Proposal for amendments to UN Regulation No.13H

This proposal was prepared by the expert from CATARC and is based on the existing UN Regulation No.13H. It is aimed at adding trigger threshold requirement, and modifying the requirement of the sampling rate, the limit of BAS deceleration and the data selection criteria of "B" BAS, indicated in bold for new and strikethrough for deleted characters.

Forkenbrock, G.J., Snyder, A., Jones, R.E., "An Evaluation of Light Vehicle Brake Assist," NHTSA Technical Report, DOT HS 810 989, May 2009.

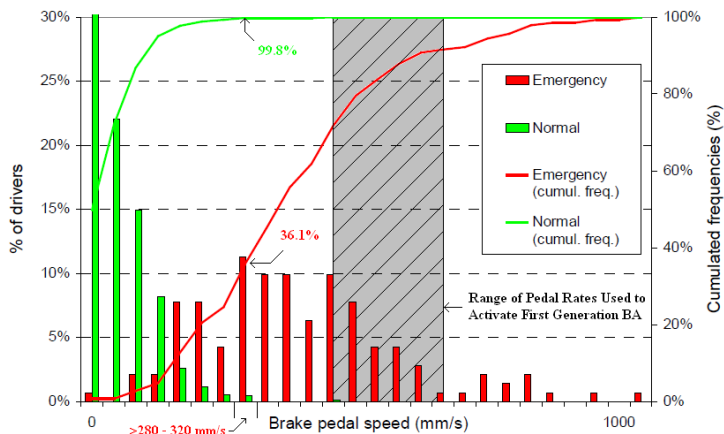
1. There should be an explicit requirement to the range of brake pedal speed to activate "B"BAS, one obvious low brake pedal speed trigger may cause a false positive accident, one obvious high brake pedal speed trigger is too difficult to achieve for a normal driver, and then lost the safety effect of BAS. A range between 472.4 to 683.3 mm/s may be used based on the document below:

22.1.2. For category B systems, define the brake pedal speed which shall be achieved in order to activate the Brake Assist System (e.g. pedal stroke speed (mm/s) during a given time interval)², **and the brake pedal speed should be between 472.4-683.3mm/s : ____ ;**

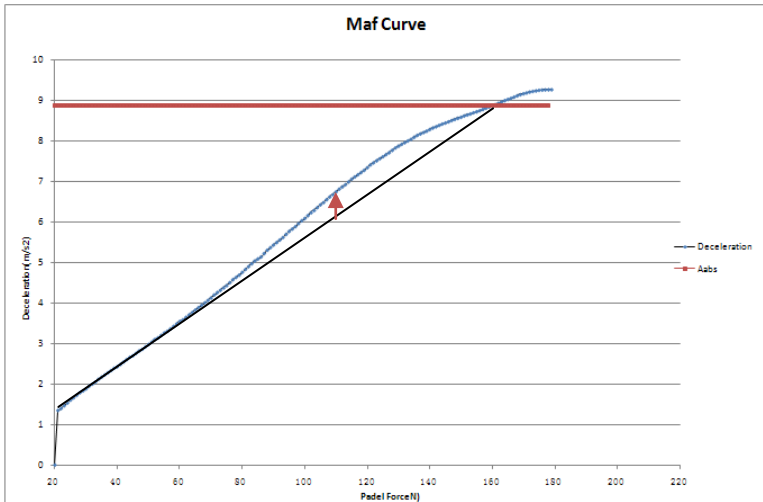
3. The deceleration requirement of activated "B"BAS should increase from 85% to at least 90%, based on the nonlinearity relationship between brake pedal force and deceleration, a brake pedal force of $0.70F_{abs}$ will achieve $0.74-0.79 a_{ABS}$ in maF curve, when using a pedal speed which is very close to the activation threshold of BAS to apply a rapid brake, a pedal force of $0.70 F_{abs}$ will achieve $0.85-0.87a_{abs}$ without the activation of BAS, which exceeds deceleration requirement of activated BAS($0.85 a_{abs}$). Based on the facts that, when the "B"BAS is

activated, the deceleration of vehicle will generally achieve 100% of a_{abs} , the deceleration requirement of activated “B”BAS should increase from 85% to at least 90%.

The presence of BAS 'B' is demonstrated if a mean deceleration (a_{BAS}) of at least ~~0.85-0.90~~ a_{ABS} is maintained from the time when $t = t_0 + 0.8$ s to the time when the vehicle speed has been reduced to 15 km/h.
